Summary of Items Discussed in 2/2023 APSEC Discussion Forum on 5 May 2023

FIGURE 1

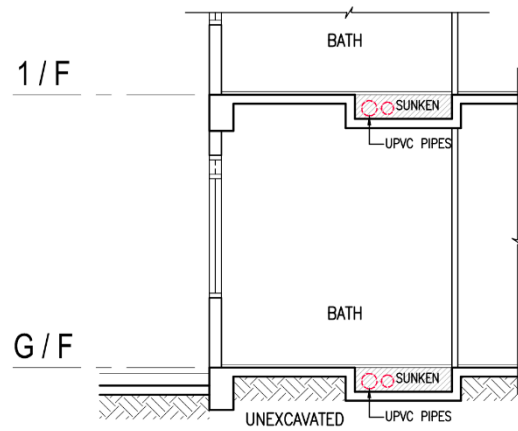
Items proposed by Convenors for Discussion	Summary of Discussion and BD's Response
	Items raised by HKIA	
1.	<p><u>Sunken Slab at Single Family House and G/F of Apartment</u></p> <p>Referring to item 4 of ADF 4/2020 held on 26 November 2020, we would like to confirm our understanding regarding the sunken slab arrangement of single family house and G/F of apartment as follows:-</p> <p>(i) Sunken slab arrangement is still acceptable at all levels of single family house and G/F of apartment to facilitate drainage repair and maintenance work. The design of sunken slab should comply with the requirements as stipulated in paragraph 5 of PNAP APP-93.</p> <p>(ii) For the sunken slab arrangement, regulation 54 of the Building (Standards of Sanitary Fitments, Plumbing, Drainage Works and Latrines) Regulations (B(SSFPDW&L)R) will not be applicable and hence it is not required to adopt cast iron pipes inside sunken slab at G/F. (Figure 1)</p>	<p>(i) According to paragraph 5 of PNAP APP-93, sunken slab design complying with the relevant requirements should be considered as an acceptable solution to satisfy the requirement set out in paragraph 3(d) of PNAP APP-93, which stated that <i>“for domestic buildings other than those intended for single occupancy or single family residence, no pipeworks for a unit shall protrude into the unit under separate occupancy on the floor below”</i>.</p> <p>(ii) Regulation 54 of the B(SSFPDW&L)R regarding the design and construction of drains and sewers under buildings were considered different from the requirements stipulated in paragraphs 3(d) and 5 of PNAP APP-93 regarding the access to drainage pipes within a building for maintenance and repair. The UPVC pipes in Figure 1 were installed within a building instead of under a building, regulation 54 of the B(SSFPDW&L)R was therefore not applicable. For underground drains and sewers, their design and construction should comply with the said regulation.</p> <p>(iii) BD advised that HKIA's understanding was correct.</p>

FIGURE 2

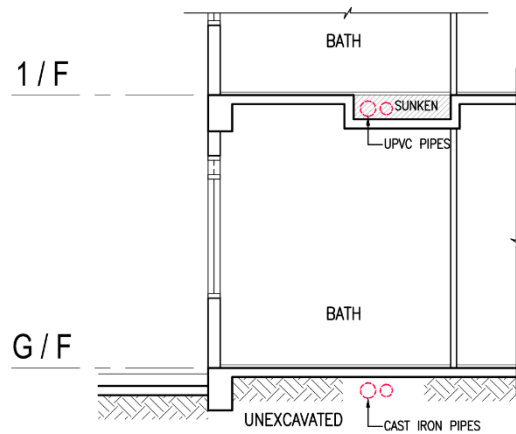
(iii) Regulation 54 of the B(SSFPDW&L)R is applicable to drainage pipes laying under the building, i.e. under the on-grade slab at G/F. (Figure 2)

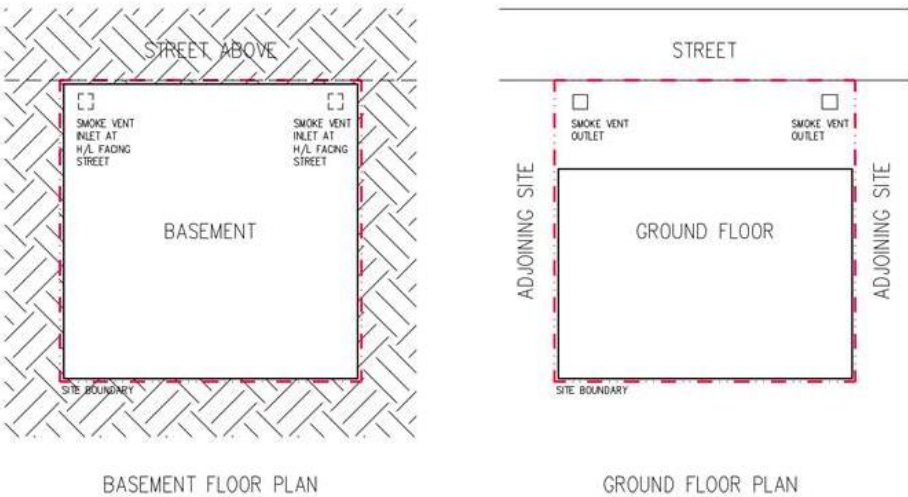
5.	<p><u>Basement Smoke Vent</u></p> <p>According to Clause C14.2(a) and (b) of the FS Code, smoke outlets should <i>“be not more than 30 m apart and situated along the street frontages or adjacent to external walls”, and “be sited at a high level, be evenly distributed around the perimeter of the building and be so arranged as to create a through draft”</i>.</p> <p>The diagram below indicates a Class A site with only one side of the basement facing the street. Smoke outlets are located only on the side facing the street within the same compartment. Our understanding is that the smoke outlets design complies with the FS Code. Please advise if our understanding is correct.</p>	<p>BD advised that provided that the external discharge points of the smoke outlets were not more than 30 m apart, the proposal illustrated in the diagram could fulfil the requirements under Clause C14.2(a) and (b) of the FS code. Item 10 of ADF 2/2015 held on 20 March 2015 was relevant.</p>

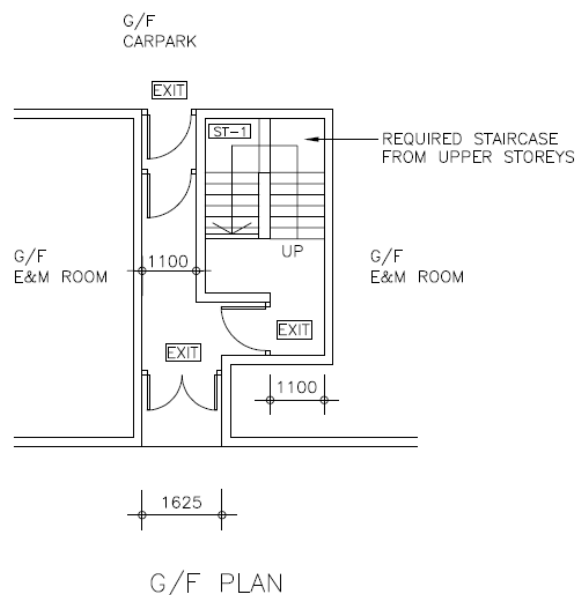
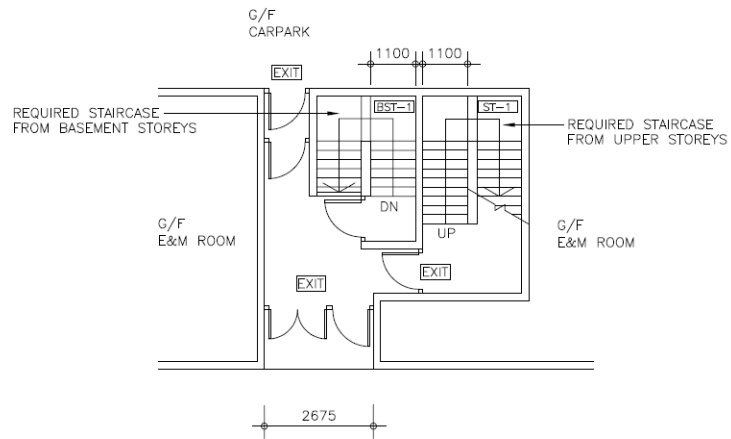
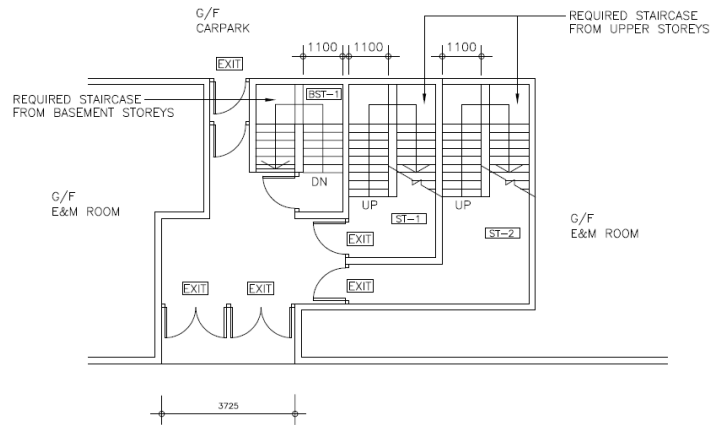
7. **Exit Route from a Ground Storey Forming Part of the Exit Route from Required Staircases – Clause B9.2 of the FS Code**

Clause B9.2 of the FS Code stipulates that an exit route from a ground storey can form part of the exit route from a required staircase, provided that the sum of exit route can meet the requirements under the said Clause.

We would like to seek BD's clarification on whether the following scenarios are acceptable:

BD advised that Scenario 1 was considered acceptable under Clause B9.2 of the FS Code, provided that the width of the combined exit route including the clear width of the exit door measured between the vertical members of the door frame, was not less than the sum of half the width required for the exit route from the ground storey and the width required for the required staircase from the upper storeys.

BD also advised that under Clause B5.2 of the FS Code, every exit route should lead directly to an ultimate place of safety. As such, Scenarios 2 and 3 were considered unacceptable under the said Clause as more than one required staircase were arranged to discharge into a protected lobby instead of leading directly to an ultimate place of safety, which should be a street or open area outside the building under Section 3 of Part A of the FS Code. Besides, Clause B9.2 was only applicable to an exit route from a ground storey which also forms part of the exit route from a required staircase. It was not applicable to the merging of two or more required staircases before discharging into an ultimate place of safety.

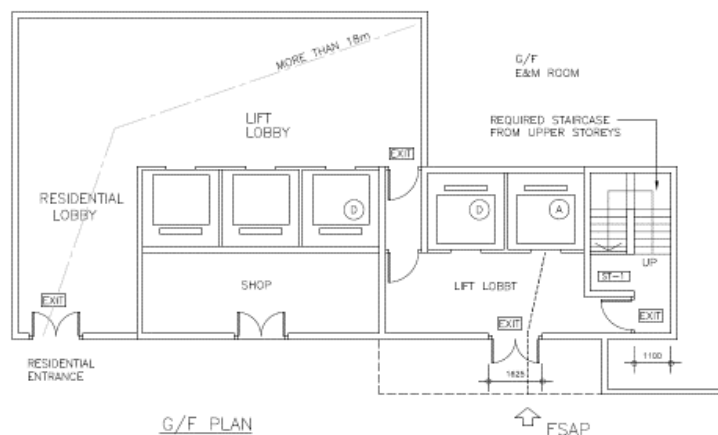
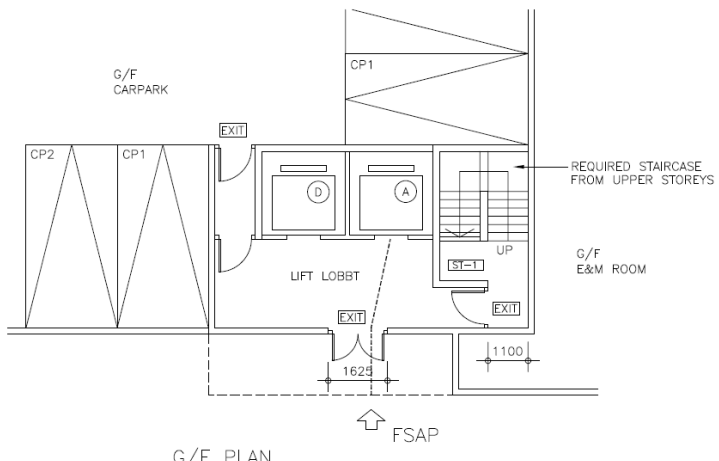
8. **Access to a Fireman's Lift at Ground Storey – Clause D7.3 of the FS Code**

Clause D7.3(b) of the FS Code stipulates that the passage from the fire service access point to the fireman's lift should be separated from the remainder of the ground storey by walls having and FRR of not less than that required for the elements of construction in the ground storey. Any opening in these walls for communication with ground storey should be through a protected lobby. We would like to seek BD's clarification on whether the communication with ground floor can also form an exit route from the ground floor in the following scenarios:

BD advised that under Clause D7.3(b) of the FS Code, the passage from the fire service access point to the fireman's lift should be separated from the remainder of the ground storey by walls having the requisite FRR. Opening in these walls might only be allowed for communication only with the ground storey.

Nevertheless, BD advised that Scenario 1 would be considered as the residential lift lobby was a public circulation space excluded from the calculation of occupant capacity and the opening was solely provided as a secondary exit for compliance with the travel distance requirements.

For Scenario 2, BD advised that it was considered not acceptable as the opening served as the exit of the carpark with occupant capacity instead of communication purpose only.

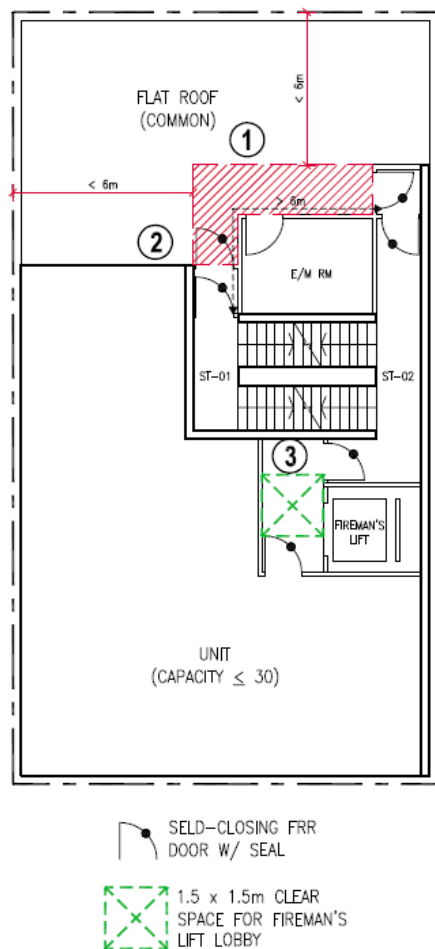
9.	<p><u>Protection of Passage for Staircase Interchange</u></p> <p>For compliance with Clause B8.2 of the FS Code for staircase interchange, it is our understanding that the requirement under Clause C9.7 of FS Code for the external wall of a required staircase and its protected lobby does not apply to the interlink passage for staircase interchange. As illustrated in the sketch below, no fire rate protection should be required along the interlink passage hatched red. Please advise if our understanding is correct.</p>	<p>BD advised that HKIA's understanding was correct. However, it should be clarified in the sketch that access to two required staircases should be available for the subject unit for compliance with Clauses B8.1 and 10.3 of the FS Code.</p>

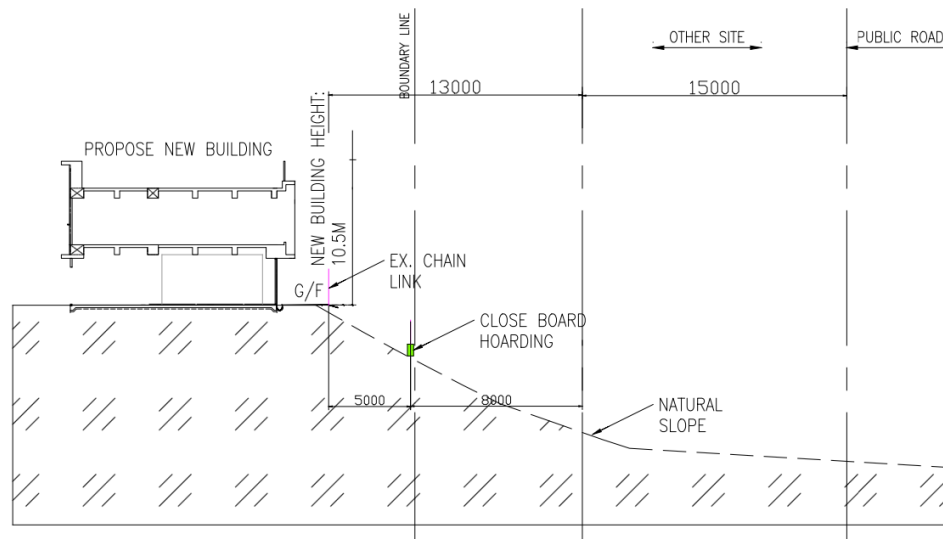
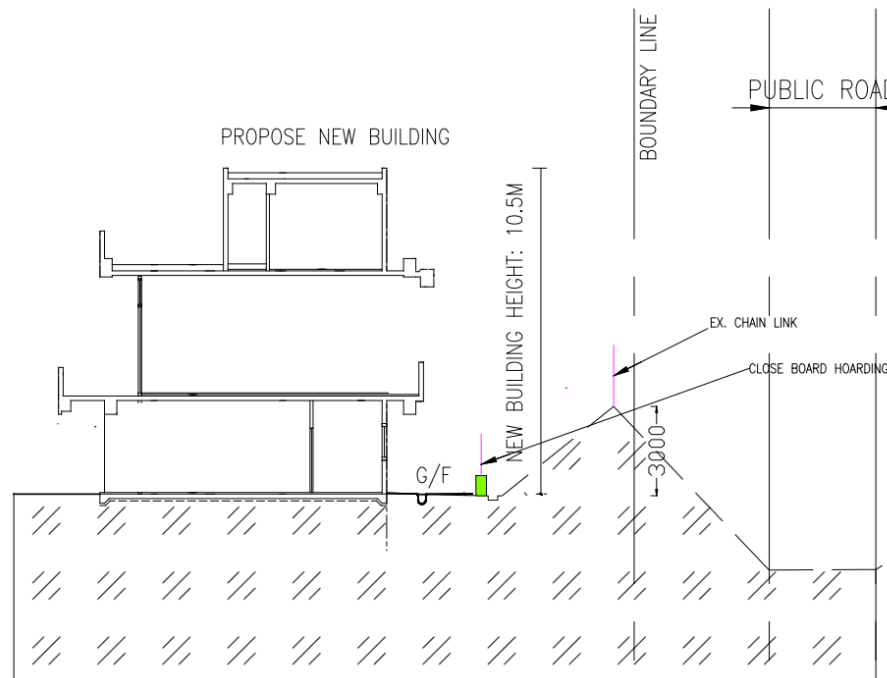
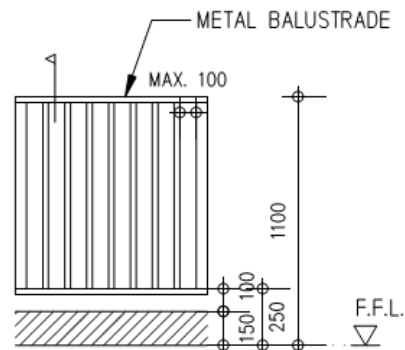
The merit for the provision of hoarding are to provide physical separation from the public to the construction site. However, for some sites with special site conditions such as the subject superstructure works may be far away from other sites or public access, it seems that close board hoarding may be considered not necessary.

The proposed building was located on a sloping site and was around 13 m away from the other site. There were existing chain link fences around 5 m away from the site boundary for physical separation. Would BD clarify

whether the existing chain link fences are adequate to provide the separation and the hoarding along the site boundary at the slope can be omitted?

There is an uphill slope in front of the proposed building and it was around 3 m in height. Would BD clarify whether the existing chain link fences are adequate to provide the separation and the hoarding at the bottom of the uphill slope can be omitted?

isolated sites, all hoardings, unless exempted by the BA, should be close boarded. According to similar discussion under item 13 of ADF 4/2022 held on 12 August 2022, in view of different site situations which warrant different safety precautionary measures, proposal of non-provision of close boarded hoarding should be considered on case basis provided that the safety of the public would not be jeopardised.

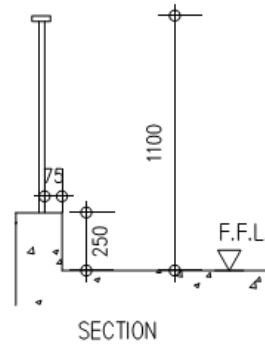
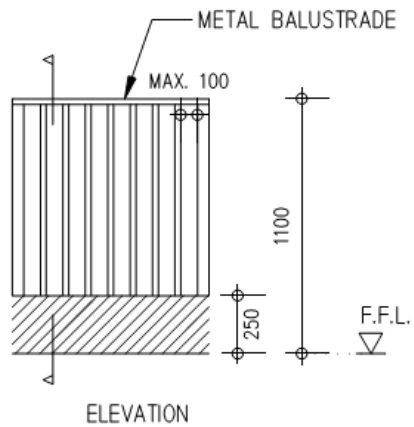
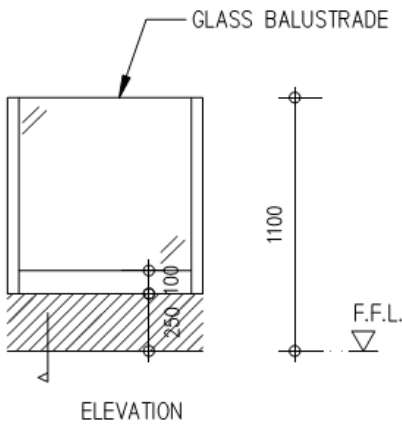
Items raised by AAP
16.	<p><u>Protective Barriers – PNAP APP-110</u></p> <p>Paragraph 3 of PNAP APP-110 mentioned that <i>“for railing type barrier on curb of less than 500 mm high, the top of the lowest horizontal rail³ should be not more than 250 mm above the adjoining floor level.”</i></p> <p>Footnote 3 of the said PNAP also mentioned that <i>“if the railing type barrier just has vertical balustrades without the bottom rail, the curb should be not less than 250 mm high with protruding width less than 75 mm.”</i></p> <p>As such, the following railing designs comply with the requirements. Please confirm if our understanding is correct:-</p> <p><u>CASE 1</u></p> <div style="display: flex; justify-content: space-around; align-items: flex-end;"> <div style="text-align: center;">  <p>ELEVATION</p> </div> <div style="text-align: center;">  <p>SECTION</p> </div> </div>

ELEVATION 1

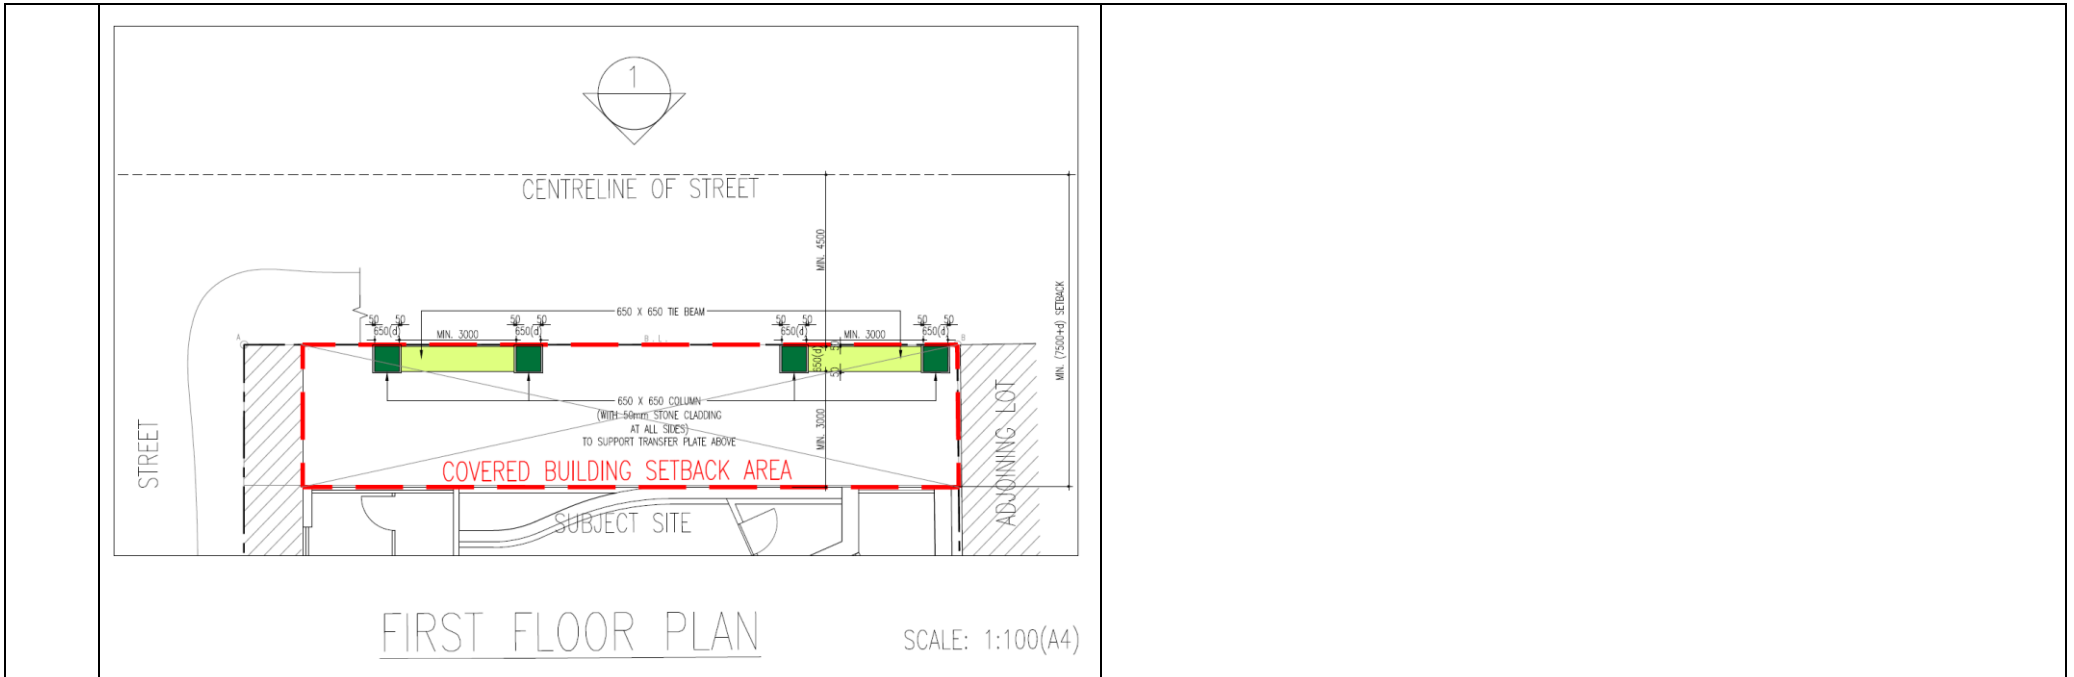
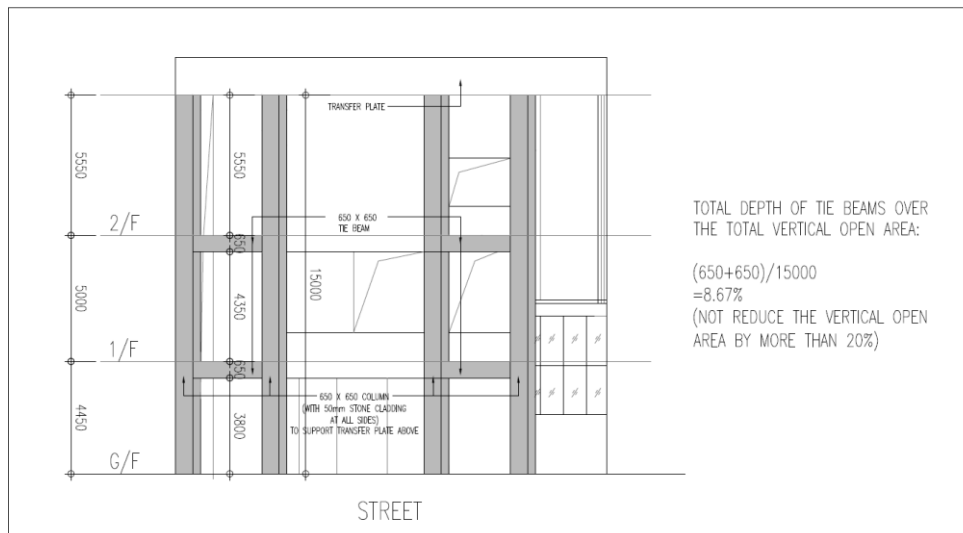
Items raised by PBSCA	
22.	<p><u>Tie Beams within Building Setback Area under Sustainable Building Design Guidelines (SBD Guidelines)</u></p> <p>Pursuant to paragraph 7(a) of PNAP APP-152, the building setback requirement under SBD Guidelines can be achieved, provided that no part of building up to a level of 15 m above street level is within 7.5 m from the centreline of street. Paragraph 8(c) of PNAP APP-152 also specifies that columns supporting the building above may be permitted within the setback area subject to requirements in Figure C2 of Appendix C to the said PNAP.</p>	<p>BD would pragmatically consider the merits of the case with the provision of tie beams, provided that the ventilation effectiveness would not be adversely affected. Depending on the circumstances of the case, BD might require further setback from the centreline of the street.</p> <p>According to item 25 of ADF 5/2019 held on 22 November 2019, the dimensions for the setback and column separation should be measured from the finished surface.</p>

In the example illustrated above, there are columns in 650 mm x 650 mm (d) in structural dimensions, with additional 50 mm thick stone cladding at all sides of column within the setback area to support the residential tower higher than 15 m above street level. Due to site constraints and small site area, the size of the columns is already maximised under the building setback requirement in Figure C2 of Appendix C to PNAP APP-152. With 650 mm wide columns spanning over 15 m high of setback area, the slenderness ratio of the column would exceed 20 and additional tie beams of 650 mm x 650 mm (W x D) between columns at 2 levels are essential to prevent buckling of columns as advised by the RSE. However, PNAP APP-152 does not specify whether tie beams connecting the columns are permitted within the setback area.

<p>Please advise if our understanding for the following issues are correct:</p> <p>(1) The principle of building setback is to maintain a ventilation corridor along the street profile. In accordance with the current practice and paragraph 7(b) of PNAP APP-27 on Gas Water Heaters, tie beams at the open end of a re-entrant not reducing the vertical open area by more than 20% is considered acceptable and not adversely affecting the ventilation requirement. Similar approach (i.e. not reduce the vertical open area by more than 20%) for tie beams can be adopted for the building setback requirement and be accepted as not adversely affecting the performance of ventilation corridor, provided that all the other requirements for building setback is complied with.</p> <p>(2) Claddings are only the facing or architectural decoration additional to the structural elements of a building according to section 26 of the Building (Construction) Regulation (B(C)R). Wall finishes, including cladding, shall not adversely affecting the performance of ventilation corridor for building setback. Hence, the wall finishes, including cladding, shall be disregarded in calculating the largest planar dimension of column (d) and the minimum 3 m clearance between structures required in Figure C2 of Appendix C to PNAP APP-152, provided that the overall thickness of wall finishes/ cladding is not more than 90 mm.</p> <p><u>The abovementioned provisions in PNAP APP-152 and APP-27 as well as B(C)R are extracted below for reference.</u></p>
